Proposed changes to D1.2 for Clauses 147 and 45

May 9, 2018

Jay Cordaro and Mehmet Tazebay

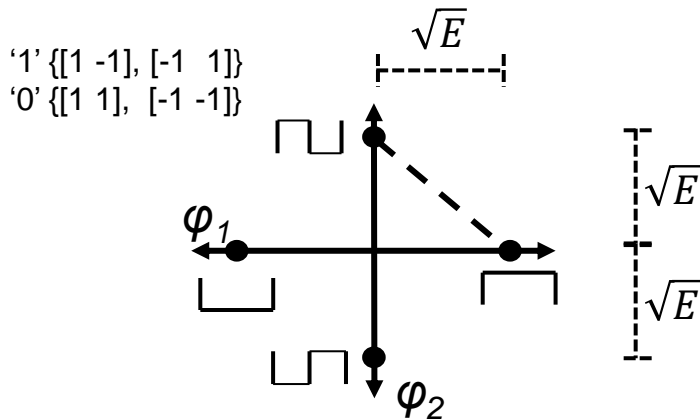
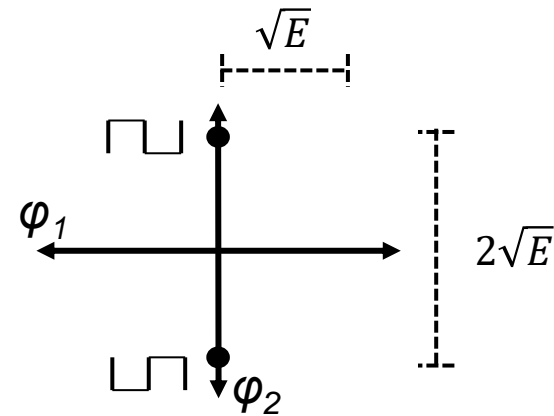
Comments #366, #367, #374 Differential Detection

- Background: [2] presented case for differential detection.

- Increased signal distance improves performance in any type of noise.
- comments #366, #367, #374 address adding trailing DME zero for differential detection

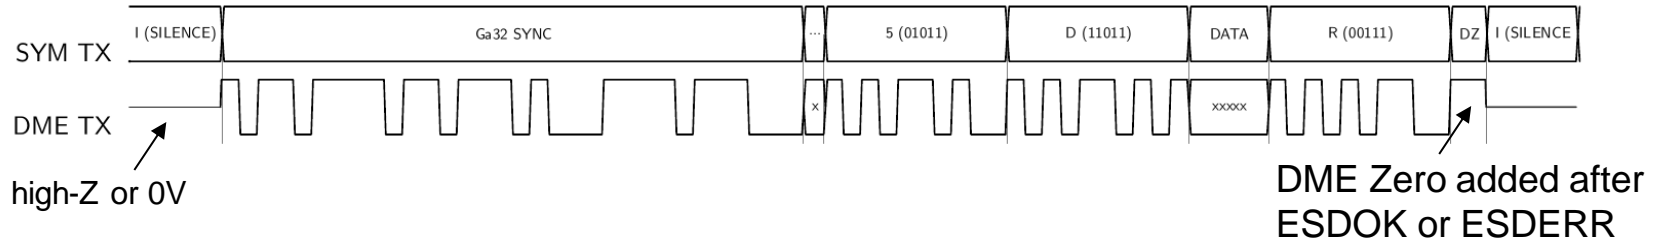
Using Beruto [3] terminology ($G(x)$ =CRC32, $D(x)$ =Payload, $S(x)$ =Scrambler Payload, $E(x)$ =scrambler error polynomial=(1 0 0 1 0 0 0 0 0 0 0 0 0 0 0 0 1))

Multiplicative scrambler causes error pattern $D(x)+S(x)*E(x)$ per Beruto.

Let $DD(x)$ =differential error multiplication (11)

Let $E'(x)=DD(x)*E(x)=(1 1 0 1 1 0 0 0 0 0 0 0 0 0 0 0 1 1)$

$\frac{E'(X)}{G(X)}$ has no residue ($E'(x)$ is not divisible by $G(x)$ over $GF(2)$)

Multiplicative scrambler error propagation combined with differential detection error propagation will not compromise the CRC performance.

Propose changes to add DME Zero suffix to ESDERR or ESDOK.

#374 Figure 147-5 – PCS Transmit state diagram (2 of 2)

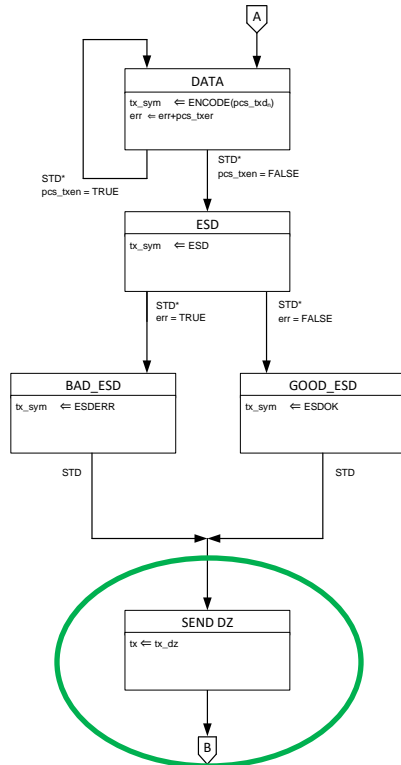
Comments #374 Figure 147-5 & #366

- After the 5B ESDOK or ESDERR symbol, a logical zero bit tx_dz is transmitted as an end delimiter. The purpose of this DME zero bit end delimiter is to assist in differential decoding of the DME 10BASE-T1S packet. See figure 147-9 and figure 147-5.

- tx_dz An end delimiter consisting of a logical zero.

{place page 134 line 3 sec 147.3.2.1}

{place below on page 134 line 42 sec 147.3.2.2 between tx_cmd and tx_sym }

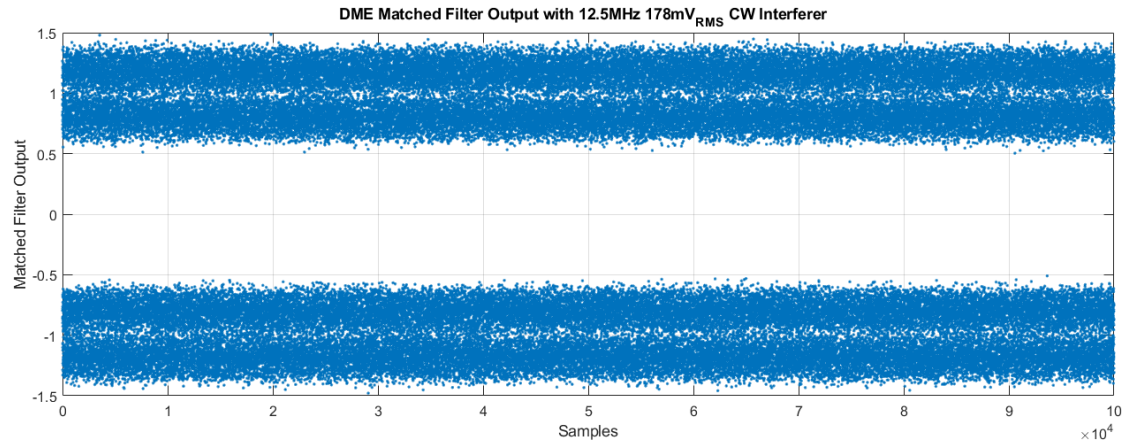
- Preamble: Ga32 SYNC (Proposed)
- TX Voltage: 1V pk-pk
- TX filtering: 2nd order Butterworth
 - fc of 30MHz
- White noise: -30dBc added
- H(t) “Max” Cable model. 100BASE-T1 cables and magnetics.
- Node 2->Node3 presented.
- CW interference: $0.178V_{RMS}$ @12.5MHz (0° phase offset)
- RX Filtering:
 - 1st order HPF fc of 1 MHz.
 - 2nd order Butterworth RX LPF fc 30MHz.
- RX: Synchronize on Ga32 SYNC, run through DME matched filter 100K bits.

Robust synchronization allows DME receiver to meet target BER requirement even with 178mV_{RMS} interferer.
